From: Bonser, Brian *RB*
Sent: Tuesday, June 09, 2009 3:46 PM
To: Austin, Joseph; Loo, Wade
Cc: Hamilton, Ruben; Musser, Randy
Subject: RE: Cooling Tower Blow down Well Results for 5/14 (state split sample day)

ATTACHMENT 4
Sheet 1 of 2
Facility Change Traveler

FCT Number 103

TROUBLESHOOTING CONTROL FORM

FCT-103
DWG 7-G-2833

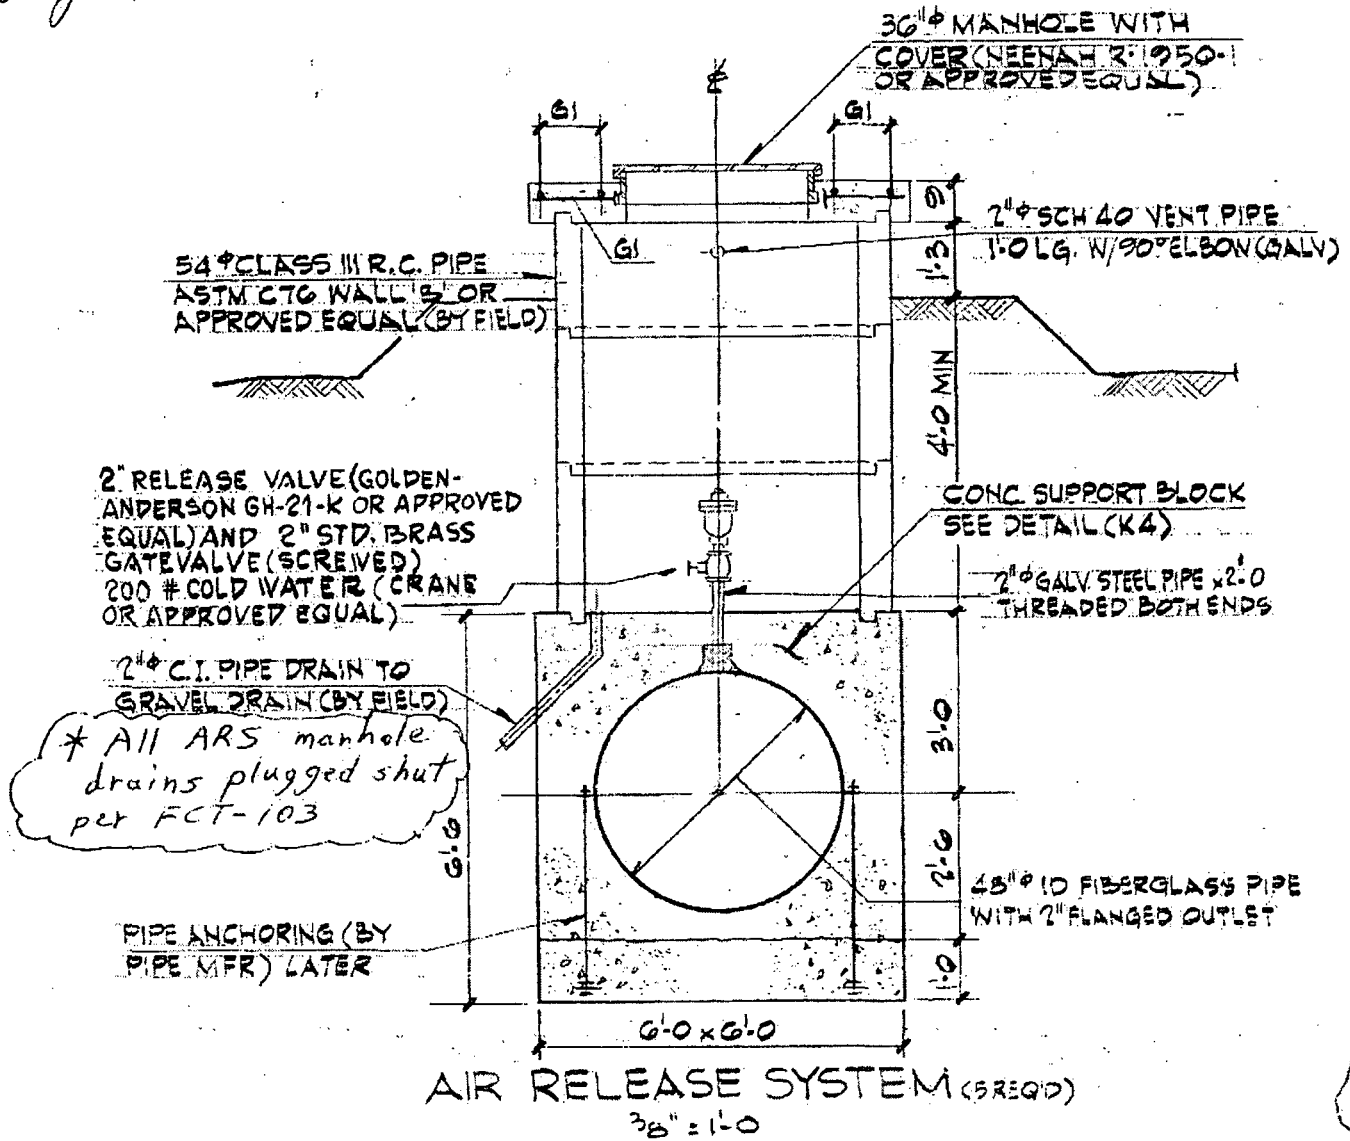
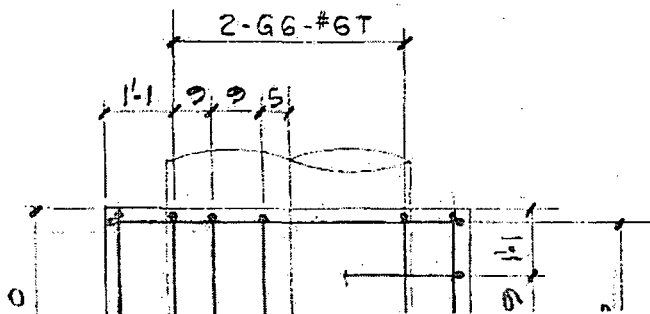
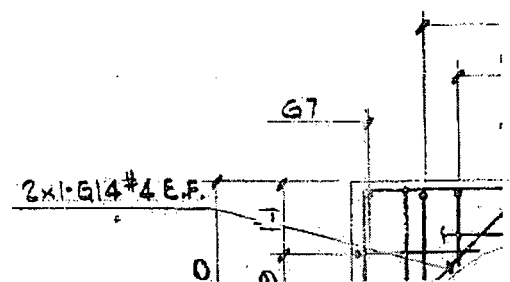
The Cooling Tower Blowdown (CTBD) system has air release points (inside air release concrete manholes) established at high points along the 48" diameter CTBD piping. Air release manhole ARS-1 has been allowing unmonitored CTBD effluent to be released into the soil adjacent to the manhole when the effluent drains out of the manhole. This FCT-103 installs a hydraulic cement plug in the 2" diameter cast iron drain line located in the floor of ARS-1. See dwg 7-G-2833 for typical details of these air release system manholes.

W/O 1525599-01	Installed Hyd-Cement 73929010.
W/O 1531486-01	Installed Hyd-Cement 73929010.
